**TOWN OF SUMMERVILLE
DESIGN REVIEW BOARD – AGENDA
Summerville Municipal Complex
Summerville Council Chambers or Zoom Virtual Meeting
October 15, 2020 4:00 p.m.**

TO: Town of Summerville CDRB
FROM: Planning Staff
DATE: October 7, 2020

PRELIMINARY LANDSCAPE PLAN
113 NORTH MAGNOLIA
STREET COMMERCIAL
SOUTHEASTERN CONSTRUCTION CO.
TOWN OF SUMMERVILLE, SC
TMS NO. 243-00-00-072

2 EXTERIOR ELEVATION- NORTH
A201 SCALE: 3/16" = 1'-0"

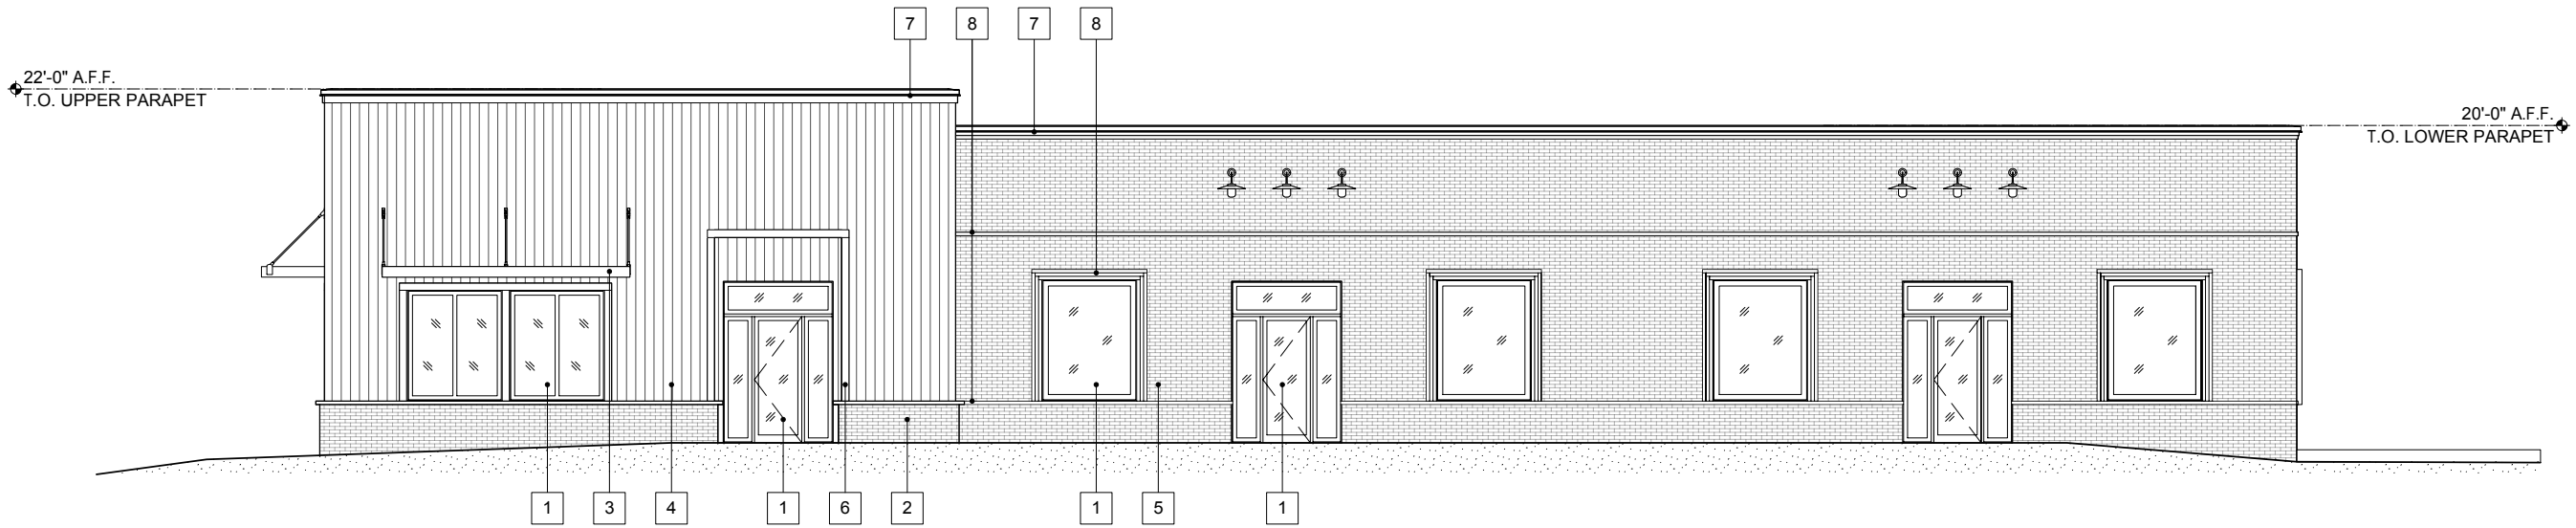
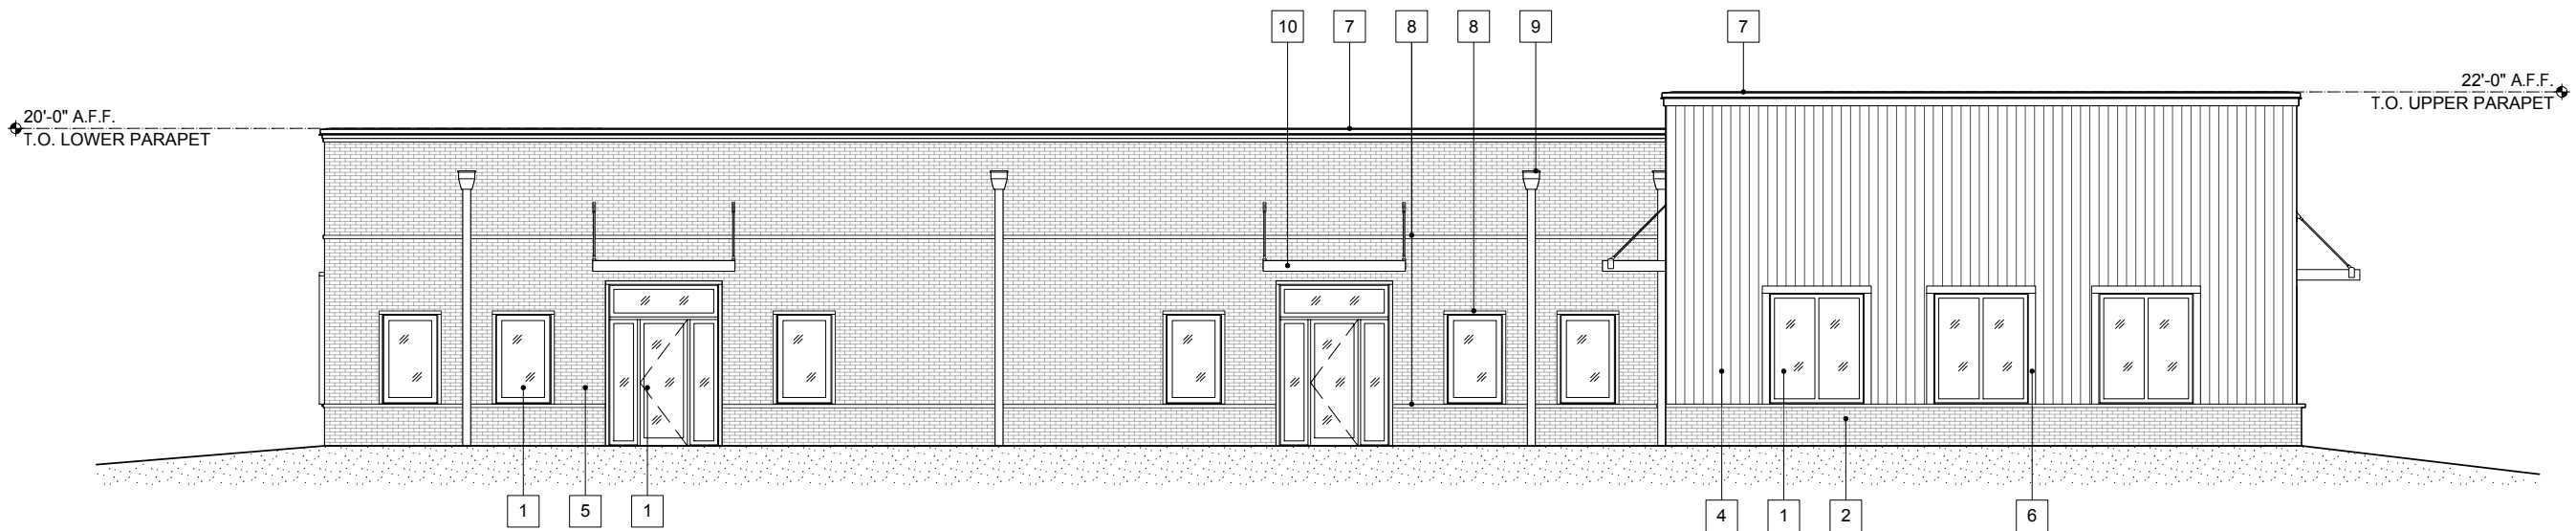
Based upon staff review the following comments must be addressed to meet requirements. Consider requesting angled parking on N. Magnolia St. The Engineering Department is requesting that the proposed sidewalks on the property extend the full width of the property on both Magnolia and 1st. Additionally, the proposed sidewalk on 1st should be wholly placed within the public ROW as opposed to straddling the property line. A Photo Metric Plan has not been submitted. As noted in the prior staff report, the Ground Floor does not meet the 65% transparency requirement of Section 4.2.9 A. This requirement can be waived by the Board. The building provides a mixture of exterior finishes, including vertical shiplap siding and brick.

SITE PLAN

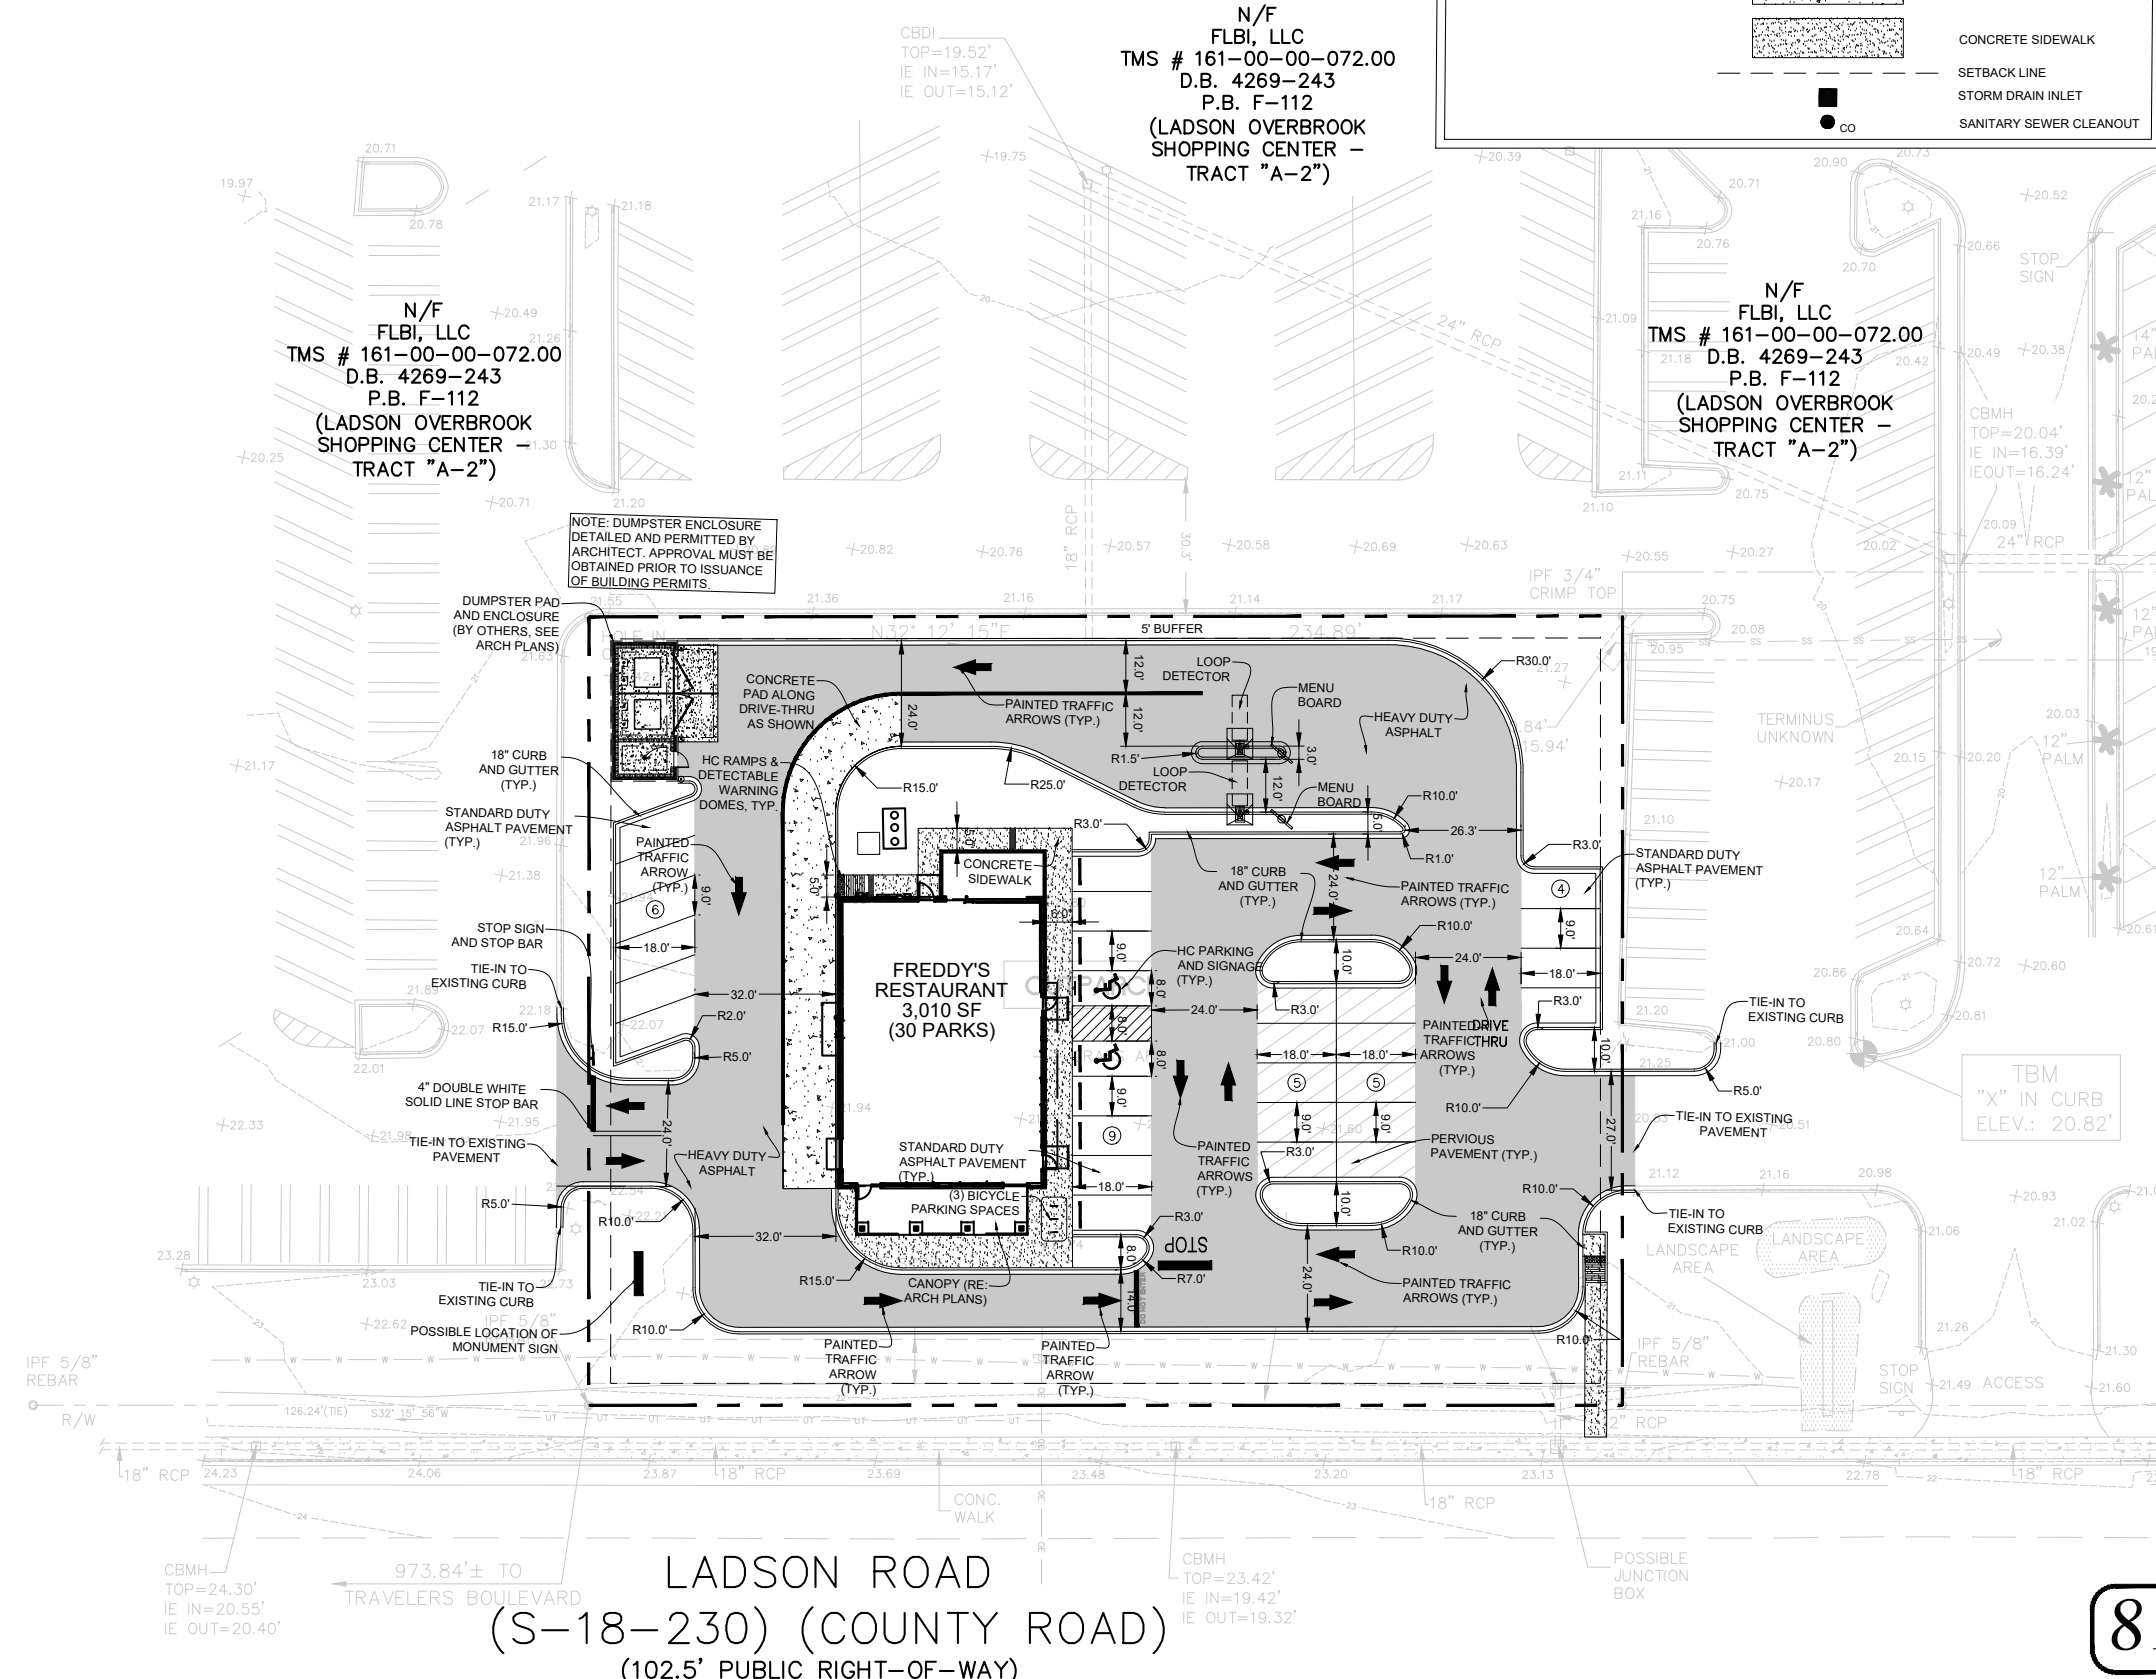
Based upon staff review the following comments must be addressed to meet requirements. A sidewalk connection to the existing sidewalk along Ladson Road has been provided. A photo metric plan has been submitted and the Average Permitted foot candles exceeds the limit established in Section 9.3.3. Average maintained foot candles should not exceed 3 in the parking area. The building provides a mix of materials including brick, and fiber cement siding, both horizontal and vertical board and baton. The proposed elevation does not meet the mandated 65% façade transparency for the first floor. This requirement can be waived by the Board.
